Dealer Principal	General Manager	Sales Manager	Service Manager	Parts Manager	Marketing	Finance
Date: February 8, 2021		Source: Aftersales			Replaces: n/a	
Bulletin #: A 02 2021 03		Name:			Supersedes: n/a	
		Title:			Group: n/a	
		Phone #:				
		Email:

Aftersales Bulletin

RR31 – Engine Earth Connections Check

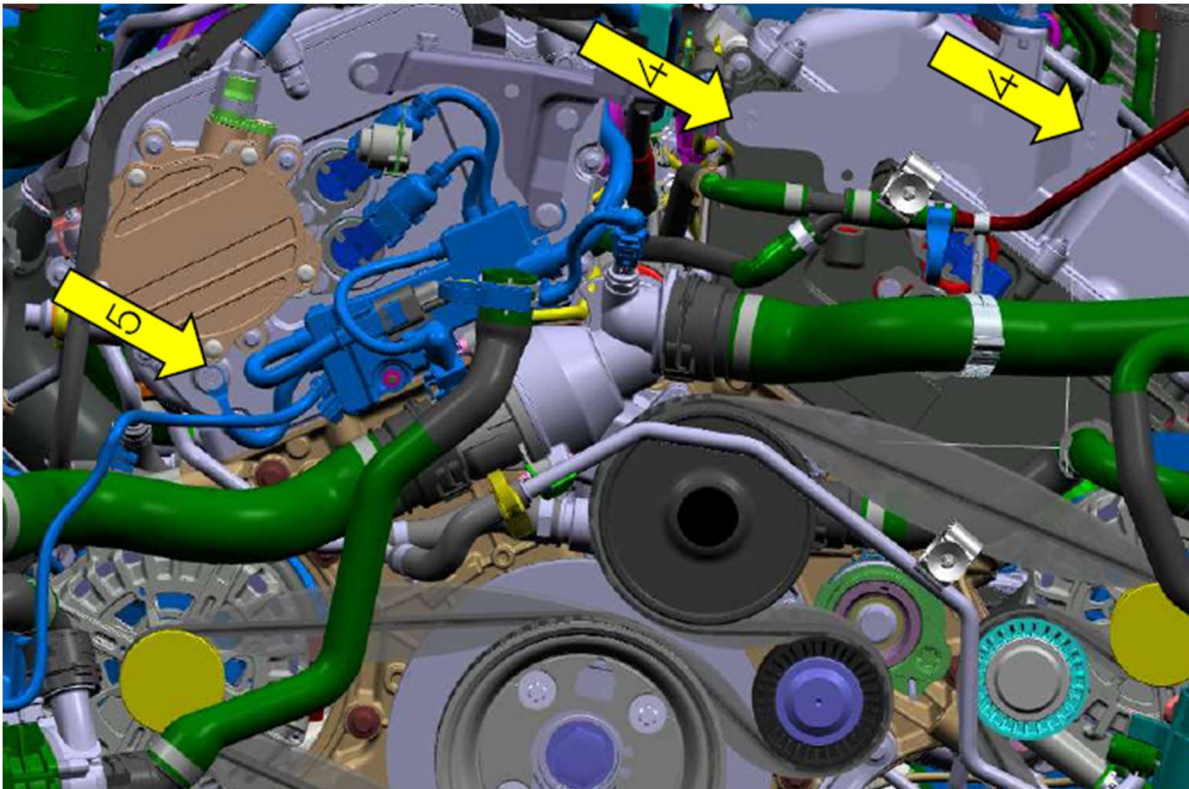
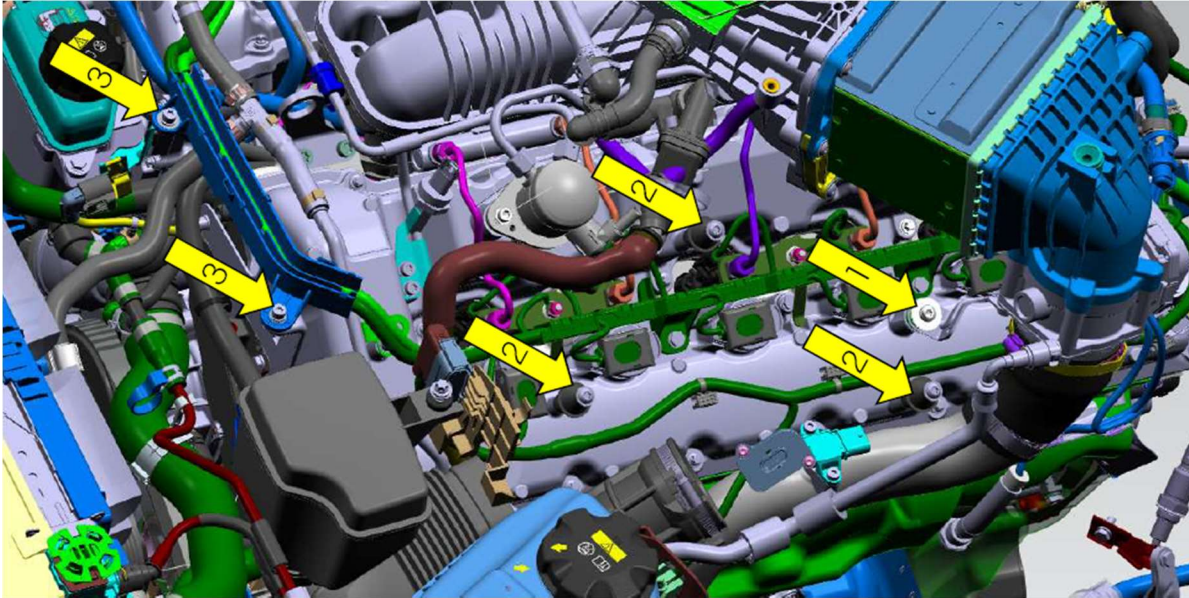
Carry out vehicle test and record any faults in the memory.

There are 16 torque screw connections on the engine that will need to be checked. All of these connections need to be undone and re-torqued to 10Nm.

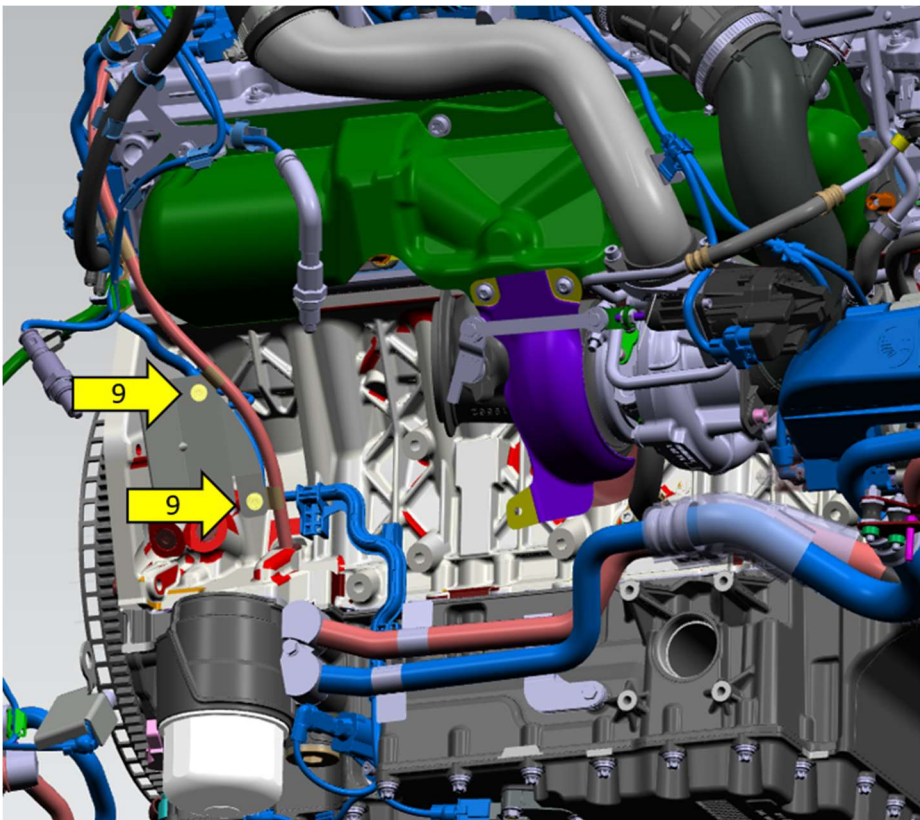
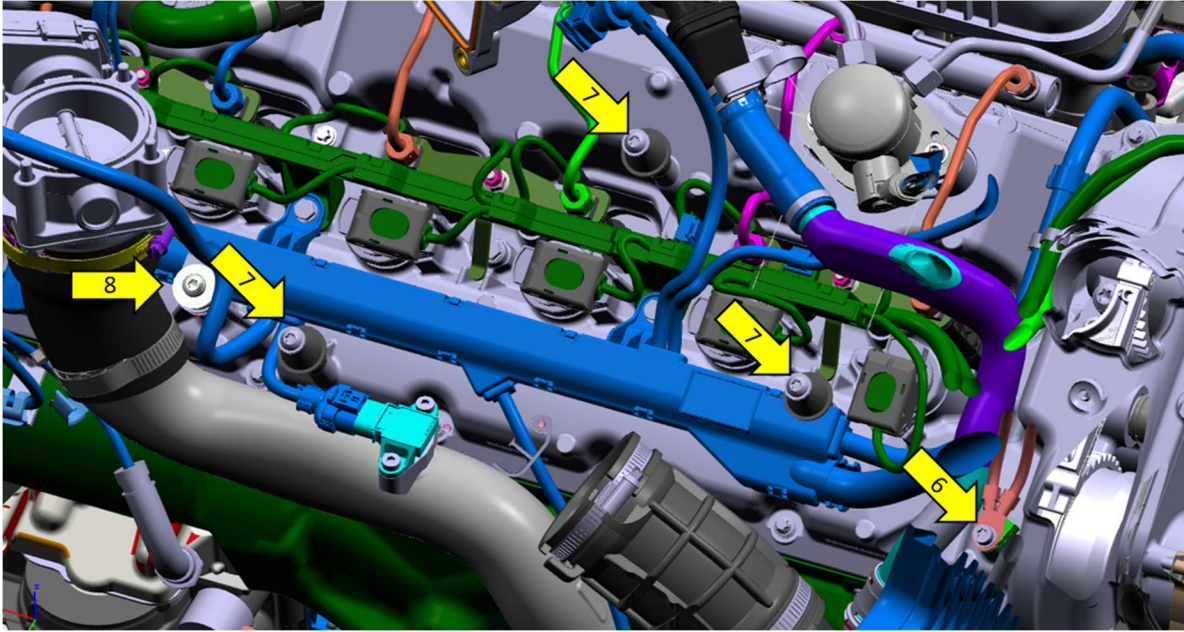
In the images below you can see the torque connections labelled with arrows.
